## EXTENDED HERITAGE CURTILAGE FOR VARROVILLE (SHR00737)

### Right of reply relating to the 14<sup>th</sup> January 2019 presentation to IPC- Landscape Reply

### Item 1: Aerial map from Slide #6 and associated text

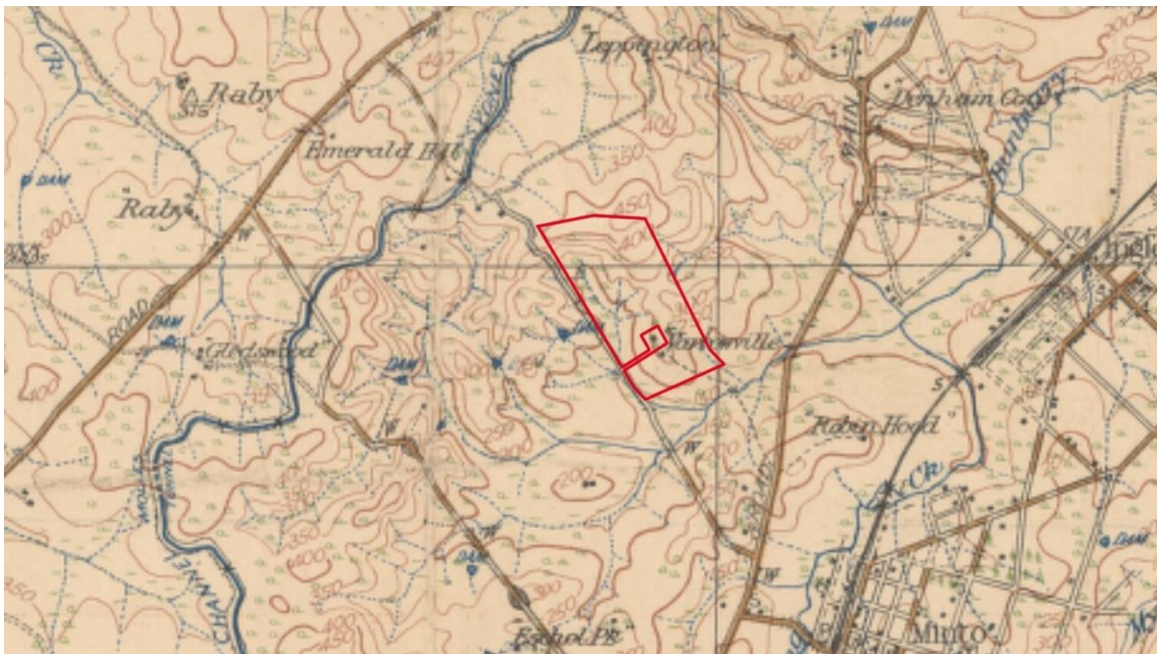
- How the addition of blue dots all over a pixelated 1947 aerial map (as shown on above OEH slide) proves anything? It is important for the panel to be supplied with an unedited copy of this aerial map to make their own interpretation of dam evidence in 1947 (appended N2).

- It is not recognised nor mentioned in the presentation that natural landscapes suffer greatly from erosion and watercourses are not static over time as is well documented in “Losing Ground: An Environmental History of the Hawksbury-Nepean Catchment”, Hale and Iremonger, Sydney 1995, commissioned by Sydney Water. This site falls within this catchment. There is a real possibility that watercourses on this site have moved over the last 200 years, especially after the consistent vegetation clearing which has occurred over the last 150 years.

- How a 1947 aerial map could be used to prove any claim relating to Charles Sturt, who owned the property for 3 years only (whilst hardly living there) more than a 100 years prior to the said aerial photo.

- Why this map contradicts the military map of 1917 (below) which shows no dam on the whole site, yet is being withheld from the presentation. (Dams are shown as blue triangles with the word “DAM” next to it)

## Item 2: image from Slide #7 and associated text

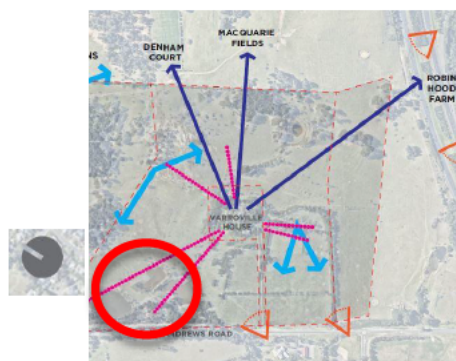
- How this sketch showing a house sitting on a knoll with 360 degrees views proves any connection with Capability Brown or Repton. Does this mean that every house sitting on knoll must be inspired by these well-known landscape architects and that nobody thought of it prior to them?
- Why no other conclusions regarding its siting were drawn, possibly relating to microclimate (taking advantage of night breezes and its relationship to the sun's movement)?

## Item 3: image from Slide #9 and associated text

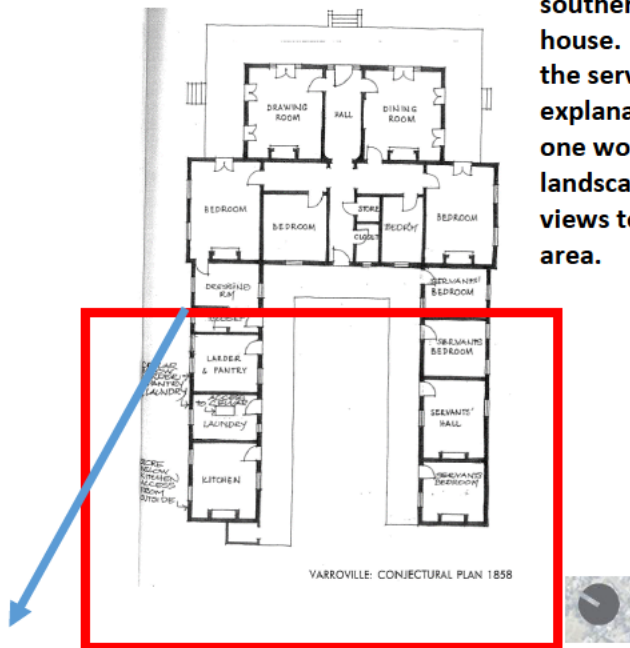
Response: This juxtaposition of these unrelated images is highly misleading. It demonstrates the speculation and lack of rigour displayed throughout the report it relies on.

- The images on the top right and left-hand side appear to have been taken recently (i.e. this century) at the angle looking south from one of the west facing windows. If the dams were purposely located with Grand English Landscapes in mind, wouldn't they have been placed in line with the window as the central Ackermann painting is trying to justify? If not, what is the purpose of the image from Ackermann?

- The present-day photographs display dams built in the 20<sup>th</sup> Century by the Jackaman's, with no evidence of any of them being there prior to 1917 (as demonstrated by the military maps on page 4 of this document), let alone in Charles Sturt's time (c.1830's) which pre-dated Varroville House. Based on this evidence, why juxtaposing a random painting next to current views? What does it prove?
- In 1858-59, when Varroville house was built, the so-called string of dam, supposedly located along St Andrews Rd and supposedly attributed to Charles Sturt, would have been viewed mostly from the

southern U-shaped end of the house. This end of the house was the servant's quarters and some explanation is needed as to why one would have purposely landscaped the site for the best views to be from the servants' area.

- On the OEH slide, the central image attributed to Ackermann has a caption relating to a "preferred" pastoral landscape. It is extracted from a 2015 unpublished dissertation by Mr P. Gibbs who is unqualified as a historian, an objector to the proposal and a part owner of Varroville house. Why does the presentation rely so much on such unqualified source? It only helps to reduce its credibility.

- One could be forgiven for thinking the juxtaposition of these 3 pictures gives them some relationship with the subject site. It should be clarified that the "painting" does not relate to Varroville in anyway and does not even relate nor substantiate anything relating to landscape setting. It can only be seen as selective and extraordinarily out of place.

Source: 1815- Drawing Room Window Curtain from Ackermann's Repository- **New York Library**

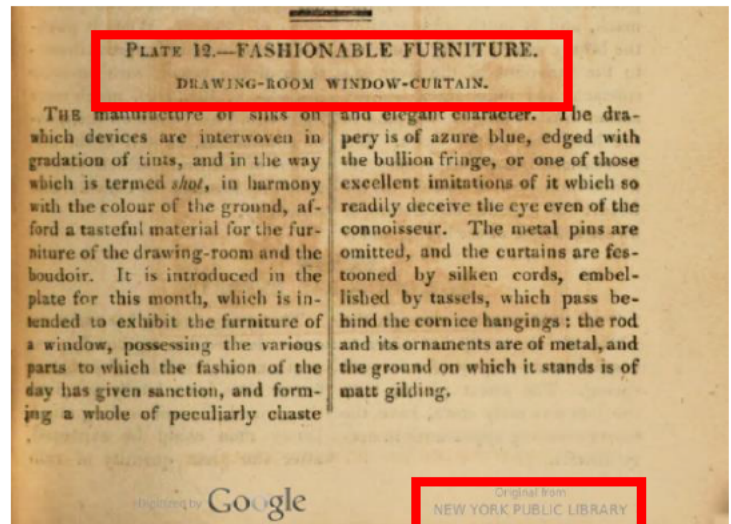
- The original caption for this image is very different and relates to "curtain fashion" as demonstrated above in our own research. What is the intention behind withholding the original author's caption? Although there is some acknowledgment in the OPP report that this painting relates to Interior Design, it is not made clear on the slide, nor does it explain how this painting is relevant to the Varroville curtilage issues. It is misleading and fanciful at best.

#### Item 4: image from Slide #11 and associated text

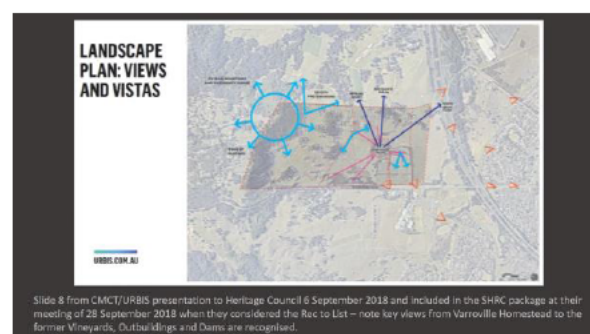
The text associated with the slide is misleading and implies an endorsement of the views by our team as having some significance. It is purposely out of context.

This analysis map has been produced by our office and features in our DA's Design Response report so I am best placed to comment on its purpose and place it into its proper context.

- We have been approached by OEH at various times to consider these views after a meeting they had with the owners' of Varroville House, no doubt influenced by the OPP report which we were not able to receive a copy of.
- We have never recognised nor labelled the views to the dams, vineyards or outbuildings as "significant". With regards to the views onto the western dams, we recognise that these views are pleasing not historically significant until proven so. Nothing put forward to date has proven their significance. To put our position in its proper context, and extracted from our Design Response Report 2017, the legend for these 3 views (shown in pink on the plan) are as follows:
